**YARRA CITY COUNCIL**

**Internal Development Approvals Committee**

**1.1 Notice of Motion No.1 of 14 March 2018 IDAC Agenda - Rescind Resolution re 66 Cecil Street, Fitzroy - PLN17/0398 - Full demolition of the existing building, and development of the land for the construction of three dwellings.**

*Existing shadows at 9am*

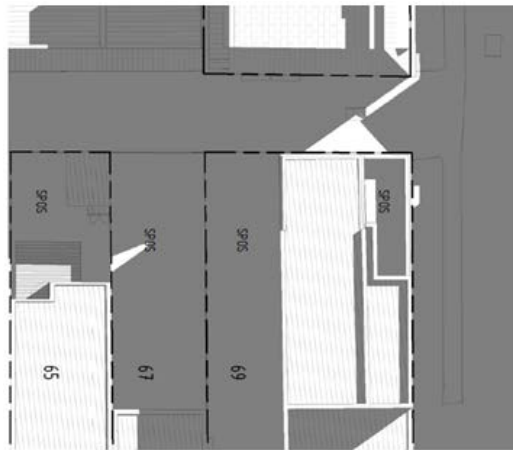
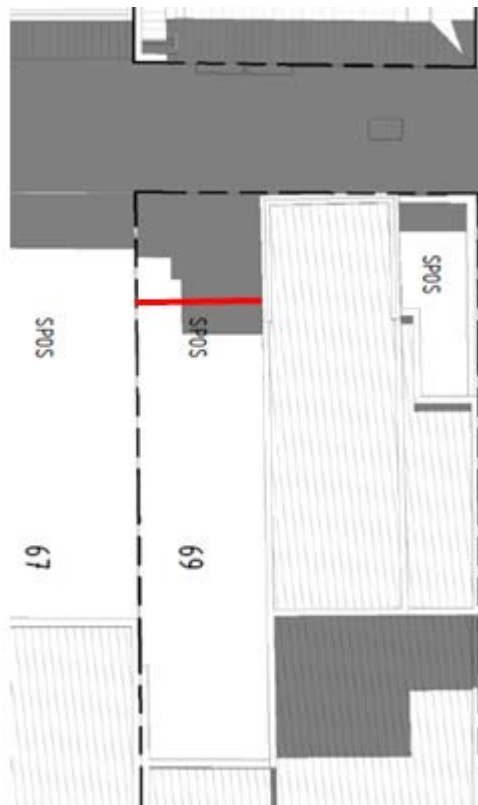
133. The image below indicates that the entire site will be in shadow at 9am, with shadows increasing slightly within the two sites further to the south-west.

134. However, the shadow diagrams do not depict the correct layout of the land at No. 69 Westgarth Street, with a recessed garage door set back from the adjacent laneway. This is evident within the aerial image below. The garage door is circled in red.

135. When comparing the photograph above to the existing shadow diagram, it is clear that the small area of land not currently in shadow is the area directly adjacent to the garage door.

Being on the northern side of this door, this area is not SPOS. The space immediately to the south of the garage door would already be in shadow at this time.

1 EXISTING EQUINOX 9AM  
TP004 1 : 200

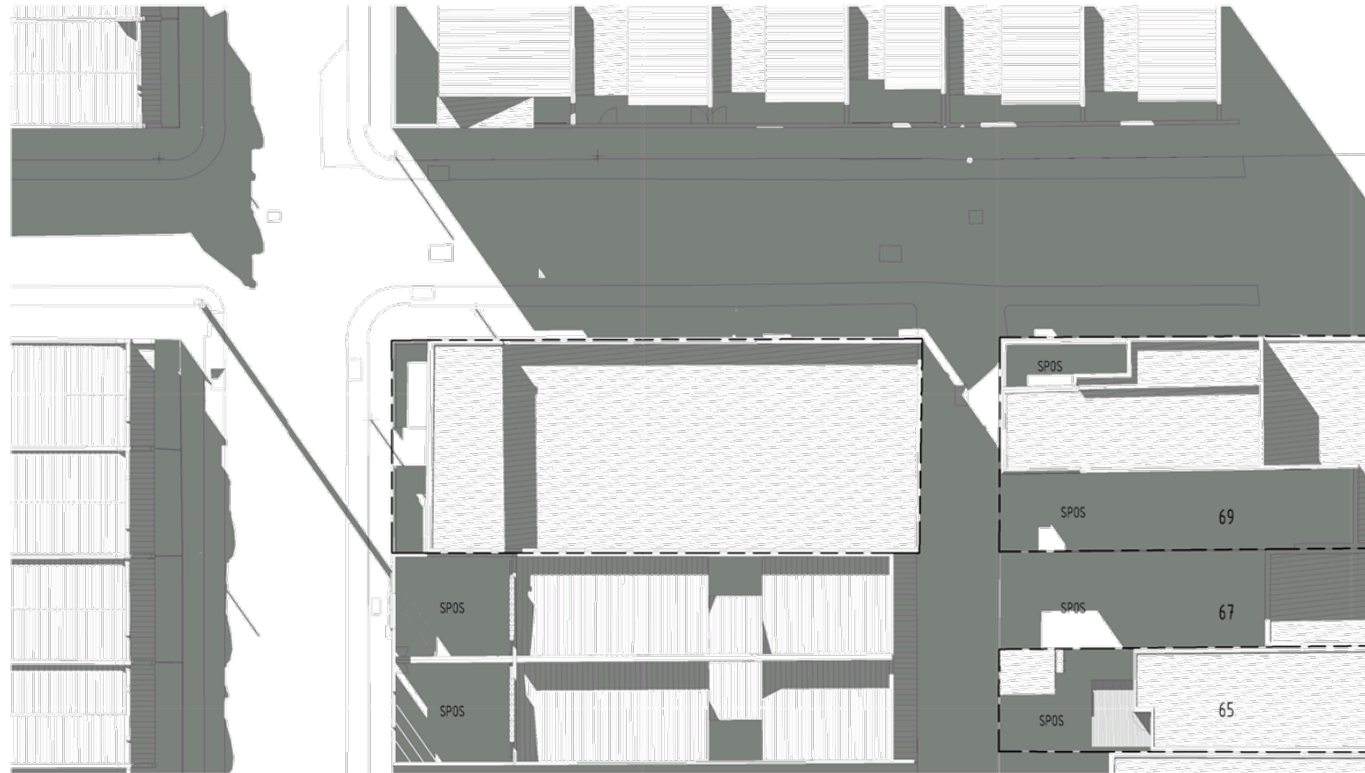
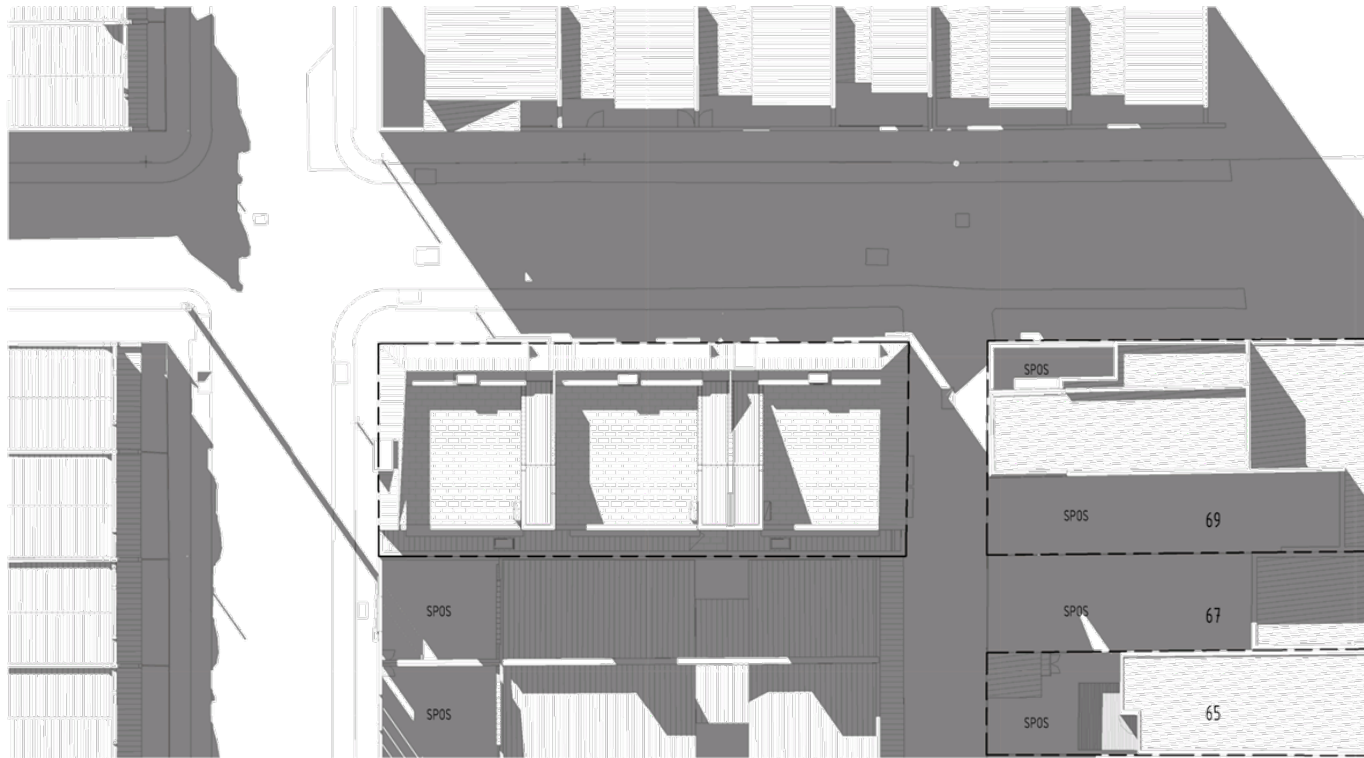
131. The shadow diagrams demonstrate that additional overshadowing will affect three sites to the south-west at 9am, with these impacts reducing throughout the day and falling largely within the Fitzroy Street road reserve by 3pm.
132. The most significantly impacted site would be No. 69 Westgarth Street, with an area of SPOS entirely in shadow at 9am of the September equinox. However, the first image below demonstrates the existing shadow conditions in this site, with the majority of this land already shadowed at this time. The red circle indicates the existing area not in shadow.

136. A minor degree of additional overshadowing will affect SPOS further to the south-west at 9am, with these shadows cast within the rear yards of Nos. 65 & 67 Westgarth Street. However shadows will dissipate quickly, with no additional shadows affecting these sites by midday. Given the location of these properties to the west of the subject site, it is likely that any additional shadows will move easterly earlier than that.
137. Additional overshadowing will affect No. 69 Westgarth Street at midday; however as outlined above, the area of space that will be shadowed either sits on the northern side of the garage door, or is located immediately to the south of the garage door and would be largely shadowed at this time. The shadow diagram below indicates the location of shadows at midday within this site, with the red line providing the indicative location of the existing garage door.

- (m) Modifications to ensure that no additional overshadowing is caused to the existing solar panels of No.64 Cecil Street from 10am at the September Equinox.

Above: Comparative scale of surrounding area.

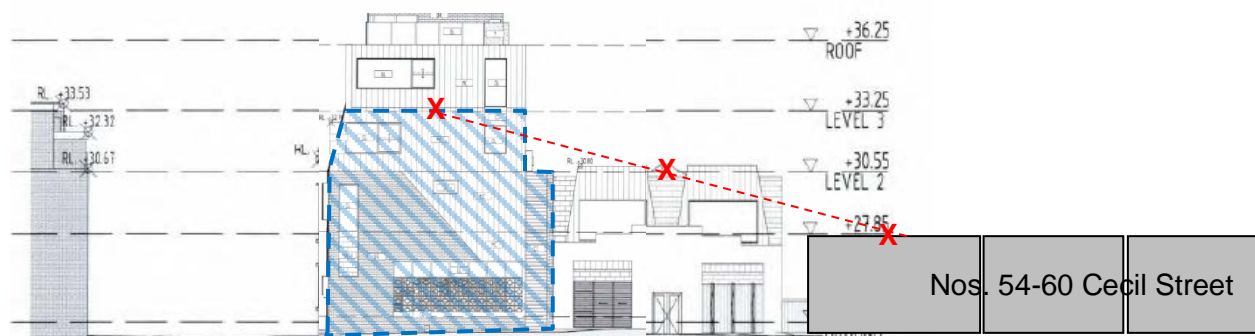
The street facade height of no. 467 Fitzroy Street (non-contributory) is about 5.3 metres rising to a maximum building height of about 9 metres.

The common street facade height of the adjacent non-contributory buildings in the street is therefore 6.1 metres which is consistent with the first two floor levels of the proposed development.

Although the proposed Levels 2, 3 and the roof terraces of the new development are slightly set back, the building will still clearly read as an almost sheer perimeter wall of about 13 metres in height. Being a corner site means that these 13 metre walls will be fully exposed to two street frontages as well as being visible from all four approaches towards the intersection. Within the Cecil Street streetscape, the height of the proposed façade will be twice as tall as the immediately adjoining townhouses (nos. 62 and 64) and will be a dramatic contrast in scale to the nearby single-storey dwellings of contributory significance.
